Site: Malvern TCE Superfund Site
East Whiteland Township, Pennsylvania

Re: Response to USEPA/PADEP Comments
Main Plant Area Revised Ground Water
Investigation Work Plan (July 2006)

Re: Main Plant Area Ground Water Investigation Work Plan (Revised), July 2006

FIGURE 1

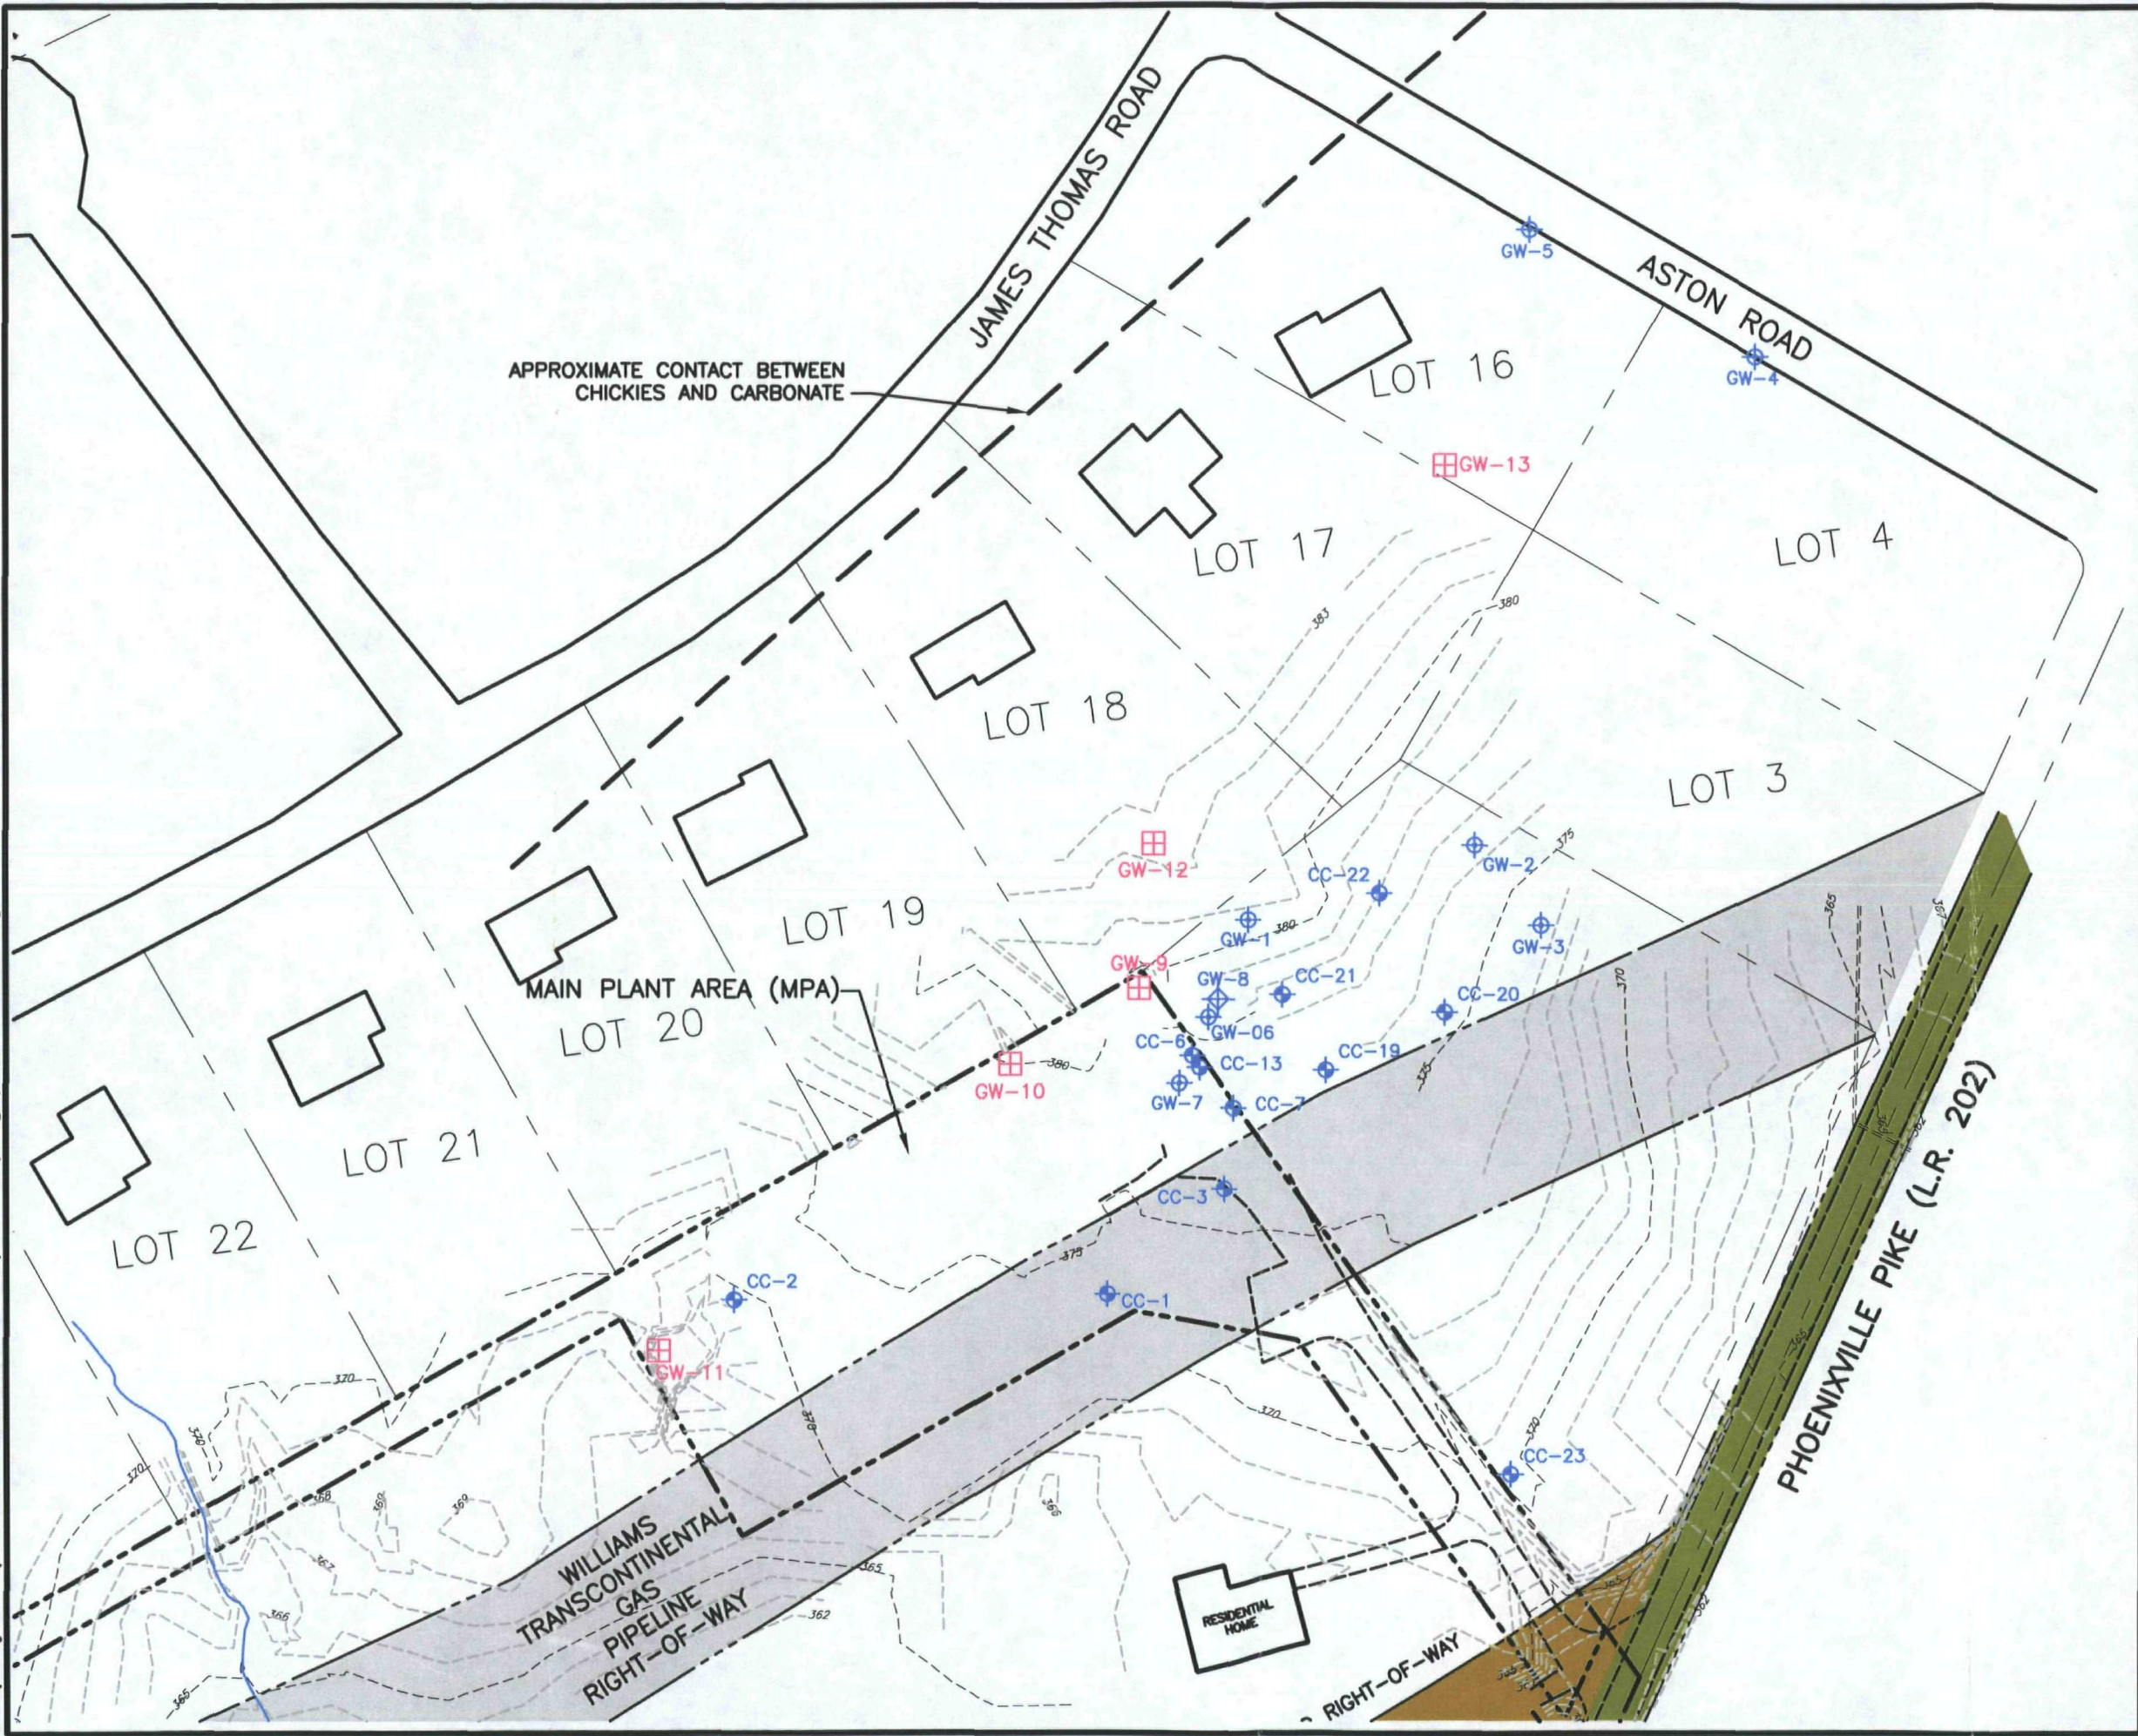
- h) *GW-13: This well is to understand groundwater quality downgradient of GW-1 and upgradient of GW-5. This is the only well that is positioned in a location that is likely to help appreciably enhance the CSM. However, the planned screened depth from 285' to 265' msl is much too shallow, likely to be screened in the overburden. This well should be drilled to competent bedrock below the shallow bedrock zone and any encountered fractures evaluated for flow, orientation, and contaminant level.*

Based on access negotiations since completion of the *Revised Work Plan*, one of the well locations (GW-13) has been revised after USEPA discussion and concurrence. Location GW-13 was moved further downgradient, from 12 James Thomas Road to 10 James Thomas Road, after the owner of 12 James Thomas Road refused to grant access for drilling. The attached Figure 1 shows the current, planned MPA monitoring well locations with the revised GW-13 location. Note that as of the date of this letter, no access has been granted for GW-12.

See response above. As noted above, this well location has been moved further downgradient with USEPA's concurrence (Figure 1).

CHEMCLENE SITE DEFENSE GROUP
MALVERN TCE SUPERFUND SITE
EAST WHITELAND TOWNSHIP, PA.
**HYDROGEOLOGIC
CROSS-SECTION A-A'**

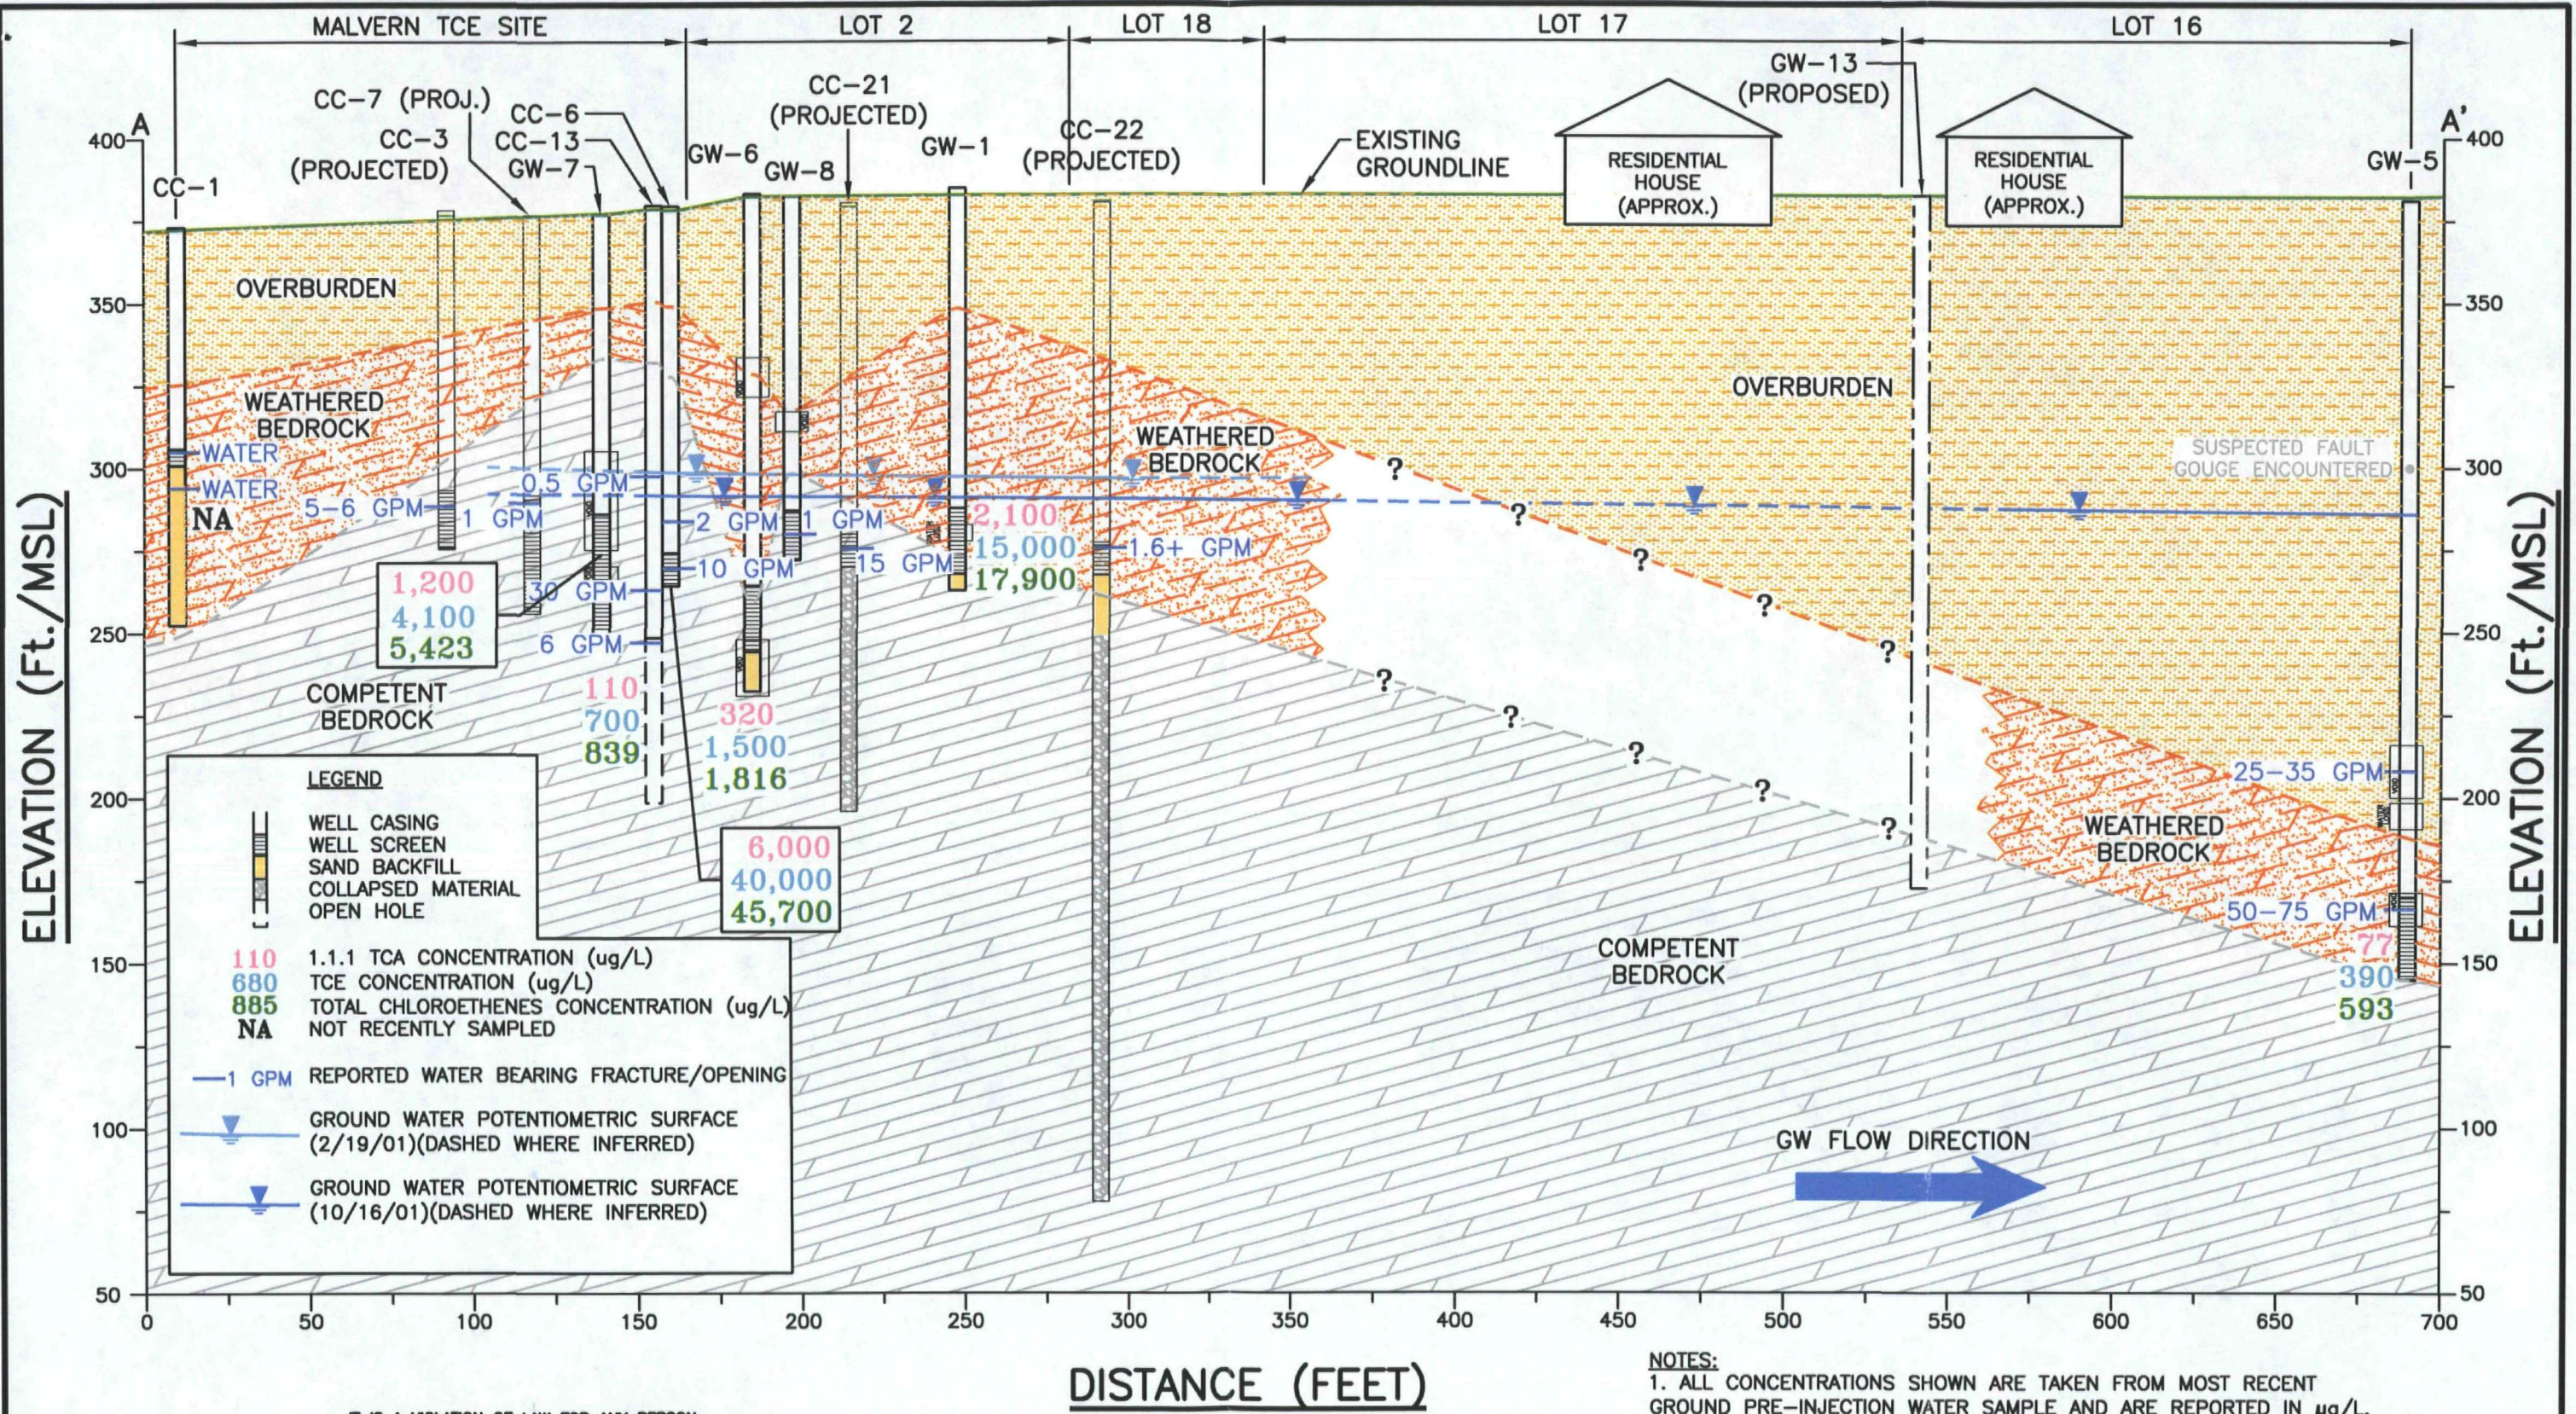
- c) *GW-8: This well is essentially duplicate of GW-6, presumable to preserve the monitoring history of GW-6 when injecting into GW-8. It does not enhance the CSM or understanding of the downgradient plume. It is also shallower than GW-6, screened in the weathered bedrock, and may not be representative of the most highly contaminated groundwater in the area.*

GW-8 was installed with screen in competent bedrock and across a distinct fracture zone. One of the geologic cross-sections for the Site was updated to include GW-8 and is attached as Figure 2. As noted above and presented in the *Bioaugmentation Plan Letter*, ground water VOC concentrations in GW-6 were over an order-of-magnitude lower than the VOC results from GW-8. These results at GW-8 were as predicted in the CSM. Rather than VOC concentrations increasing with depth as suggested by this comment, VOC levels dropped off significantly with depth as observed in GW-6 and other wells in the area having deeper screen intervals (e.g., CC-6/CC-13 results).

For the GW-13 location, the geologic materials where the well screen will be placed will be identified based on drilling observations. As shown on the attached Figure 2, the geologic material present at depths equivalent to the shallow bedrock zone targeted at the MPA may be overburden or weathered bedrock (possibly fault gouge). Based on drilling observations, the
